dsPIC33CH128MP508 Family Silicon Errata and Data Sheet Clarification

The dsPIC33CH128MP508 family devices that you have received conform functionally to the current Device Data Sheet (DS70005319D), except for the anomalies described in this document.

FIGURE 1: I/O RAMP

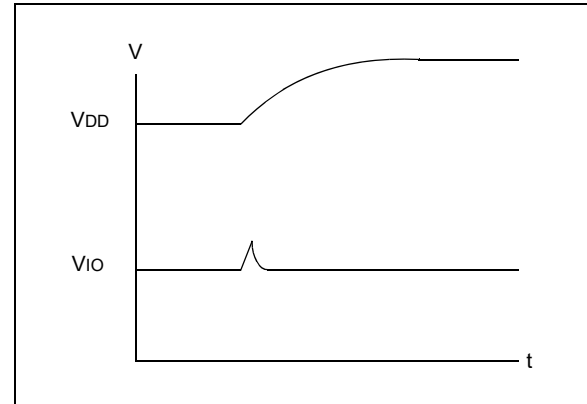
During a fast device power-up, when the V_{DD} ramp is less than 4 mS, the I/O pins may drive up to 100 μ A current for a duration of up to 10 μ S (Figure 1).

Example applications affected may include complementary power switches, where a transient current shoot-through might occur.

High-voltage applications with complementary switches should power the high-voltage 200 μ Sec later than powering the dsPIC[®] device to avoid the current shoot-through. This behavior is specific to each device and not affected by aging.

1. Slow down the V_{DD} ramp time (greater than 4 mS for V_{DD} to ramp 0V to 3.3V).
2. Ensure the circuitry that is connected to the pins can endure this pulse.
